PRODUCT / PROCESS CHANGE NOTIFICATION

1.1 Company		STMicroelectronics International N.V
1.2 PCN No.		MDG/22/13702
1.3 Title of PCN		AMKOR ATP (Philippines) TSSOP20 package HDLF to XDLF conversion for STM8AF6213x and STM8AF6223x listed AUTOMOTIVE products
1.4 Product Category		TSSOP 20 package products listed- automotive products - STM8AF6213x - STM8AF6223x
1.5 Issue date		2022-11-03

**PRODUCT/PROCESS
CHANGE NOTIFICATION
PCN13702
– Additional information**

**AMKOR ATP (Philippines) TSSOP20 package HDLF to XDLF
conversion for STM8AF6213x and STM8AF6223x listed
AUTOMOTIVE products**

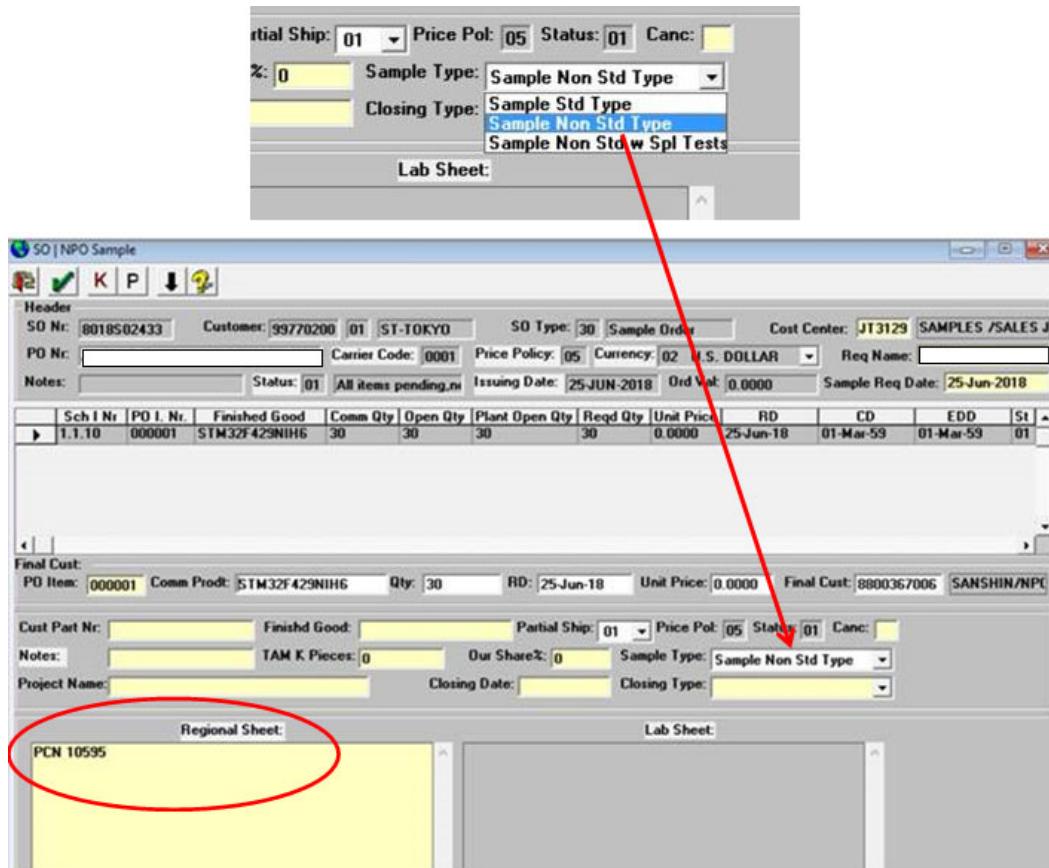
How can the change be seen?

The standard marking is:

Existing Marking	Added Marking
 (e4) PP LLL - - - - ● COO YWWR	 (e3) PP LLL - - - - ● COO YWW SS R

SS : aSsembly Sub-Lots enhanced traceability code
